ETIHAD STADIUM NORTH STAND EXPANSION **NON-MATERIAL AMENDMENT SUMMARY**

26/07/2024

NSE-POP-ZZ-ZZ-TR-A-008112

Section detail through perforated panels.

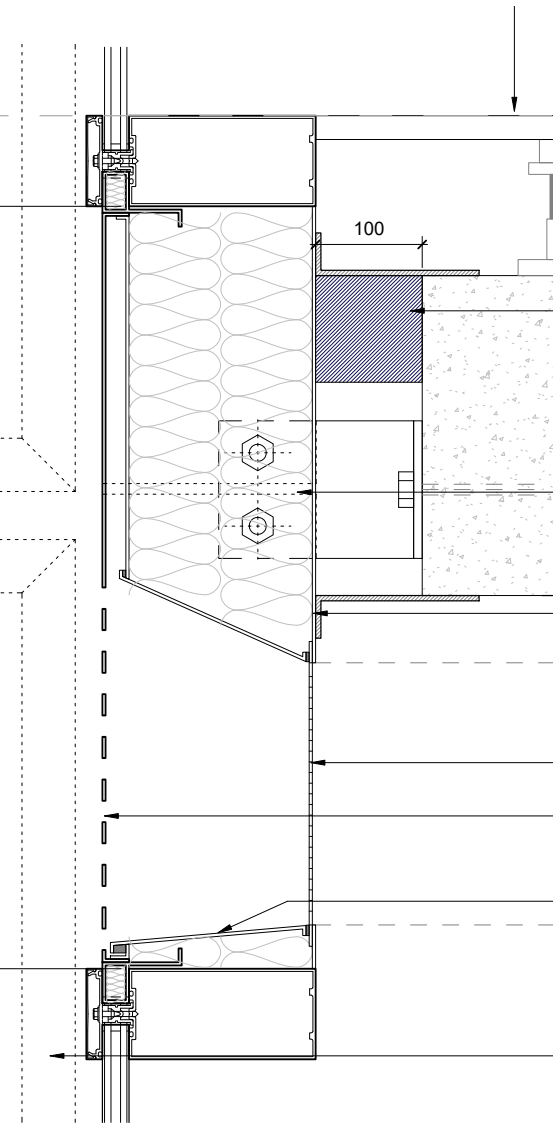
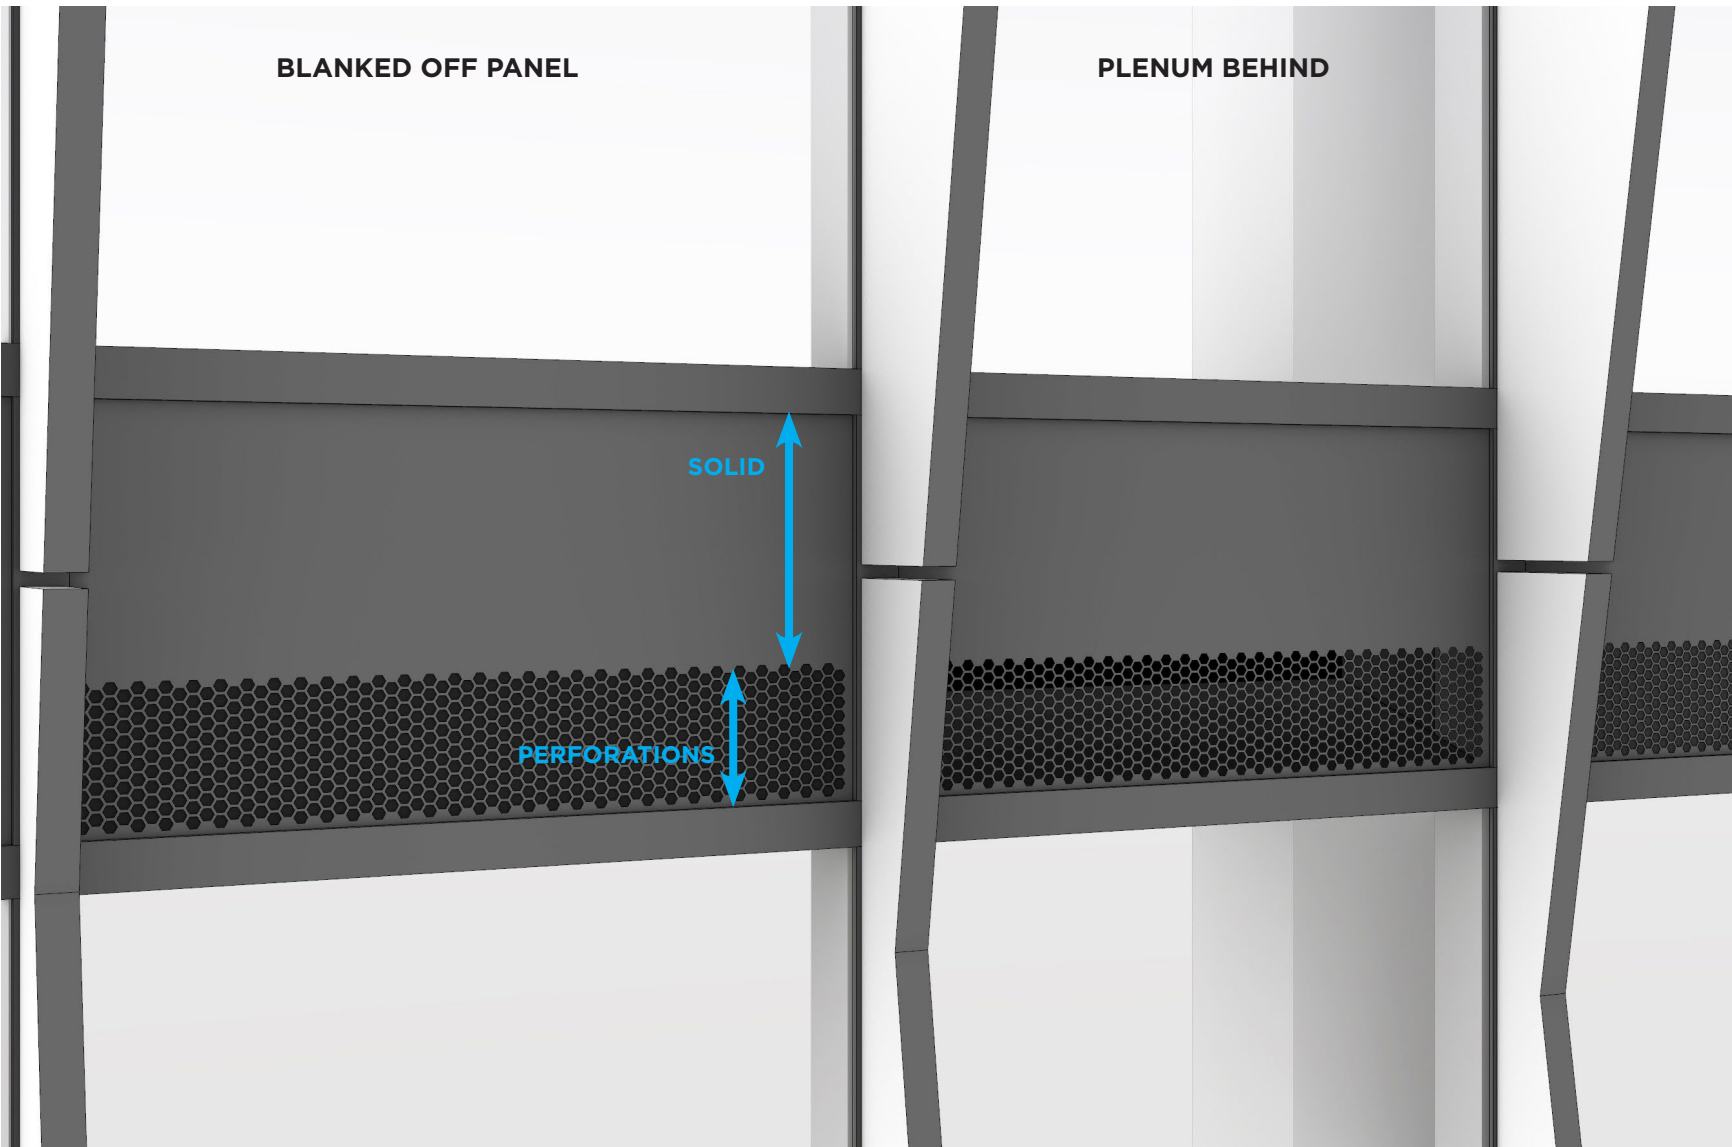
The proposed perforated panel accommodates the different appearances when the perforated panel is blanked off behind or when there is an active plenum behind the perforations.

By limiting the height of the band (as shown in the image to the right) and maintaining full-width plenums between curtain wall mullions, there is always separation between the two conditions.

The blanking off panel and the inside of the plenum will both be coloured black to further minimise the distinction between them.

This design also reduces the mass of the cladding strip by breaking apart the appearance of the two parts (flat and perforated) of each panel, more closely mimicking the original intent of the louvres than a full-height perforated band would do. This also reduces the visual impact of a panel that is approximately 800mm high.

Elevation of the proposed perforated panels.

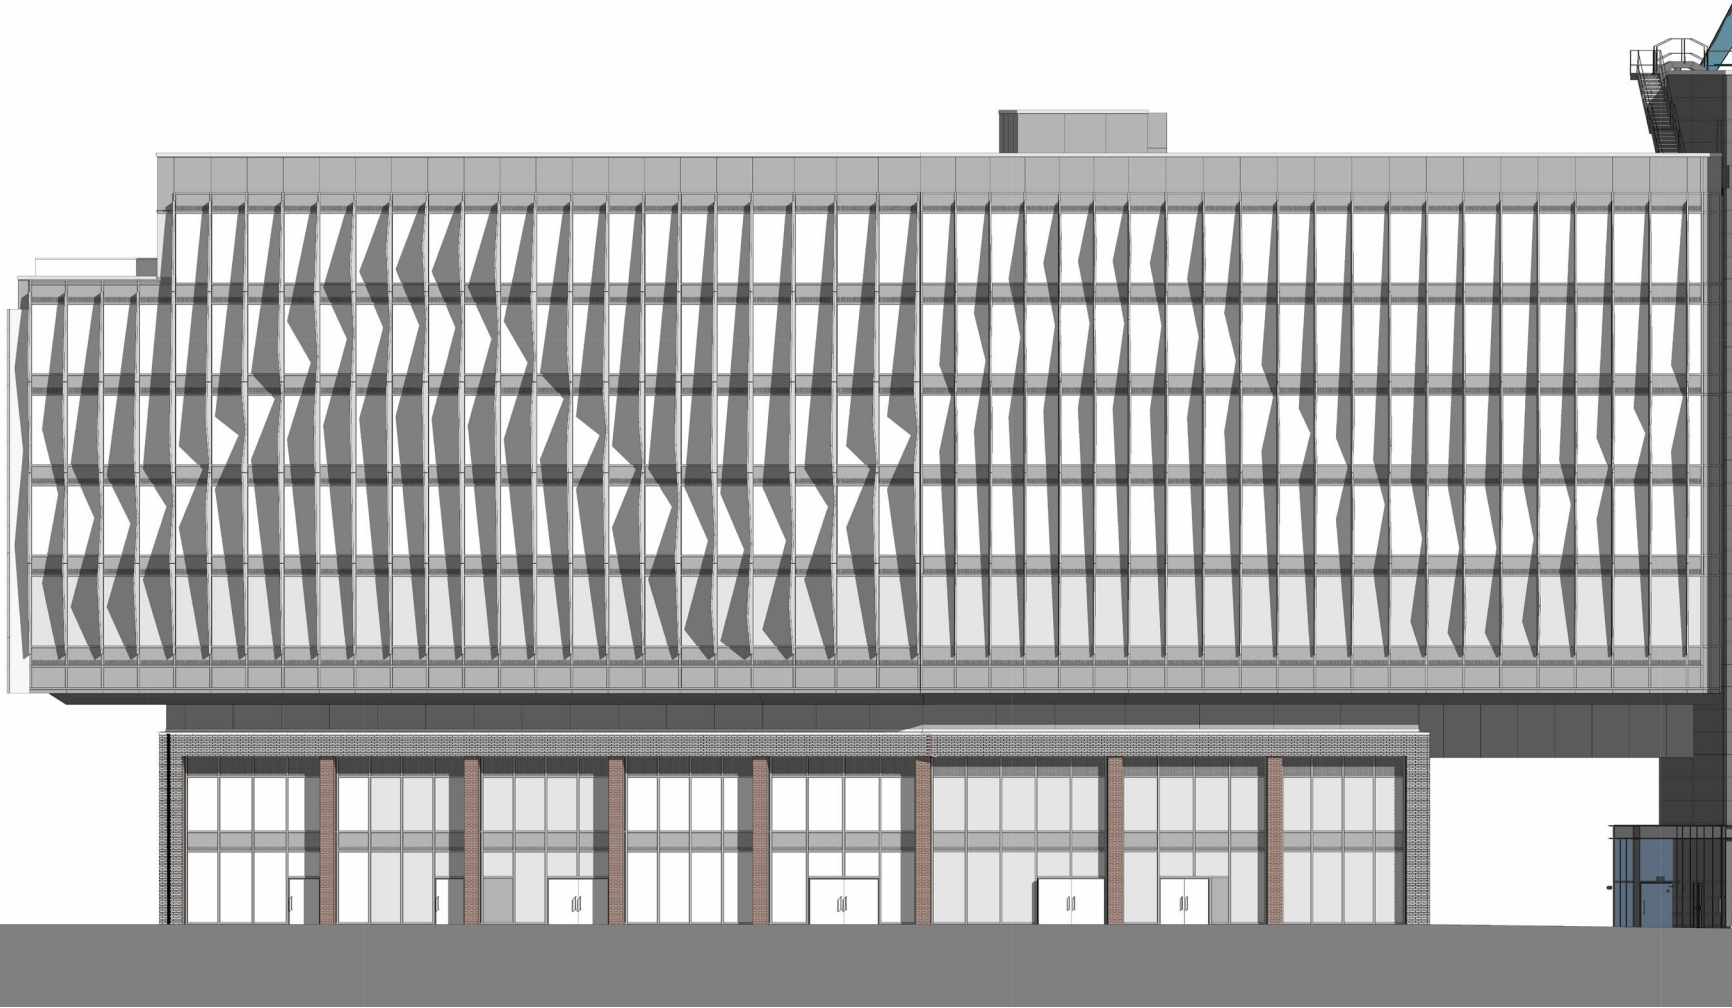
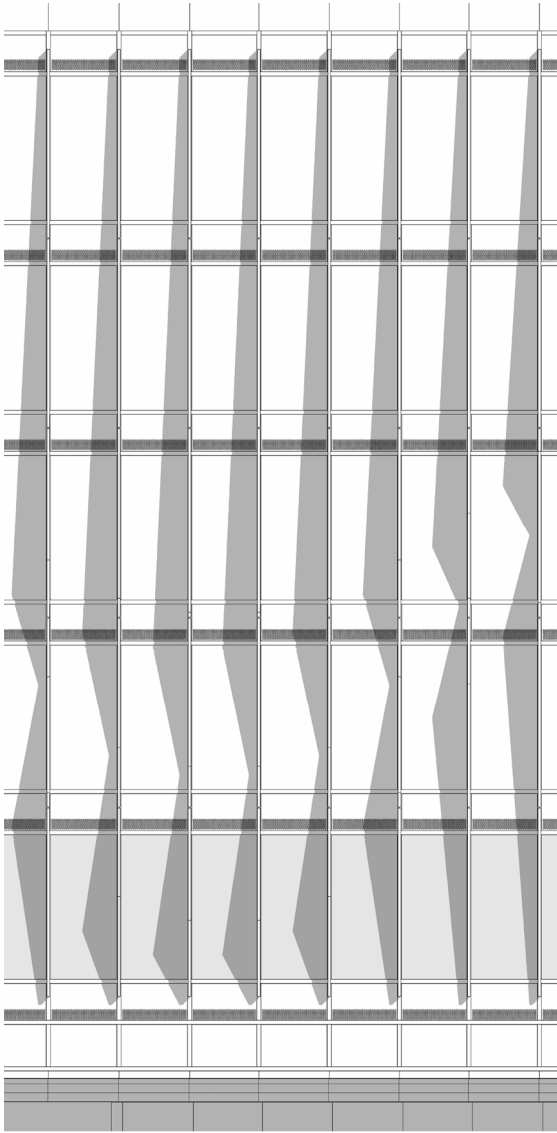
As a result of keeping the perforations to an elegant datum, very similar to that of the louvres that were shown in the original planning application, the overall impact on the facade of the update to perforated panels is negligible.
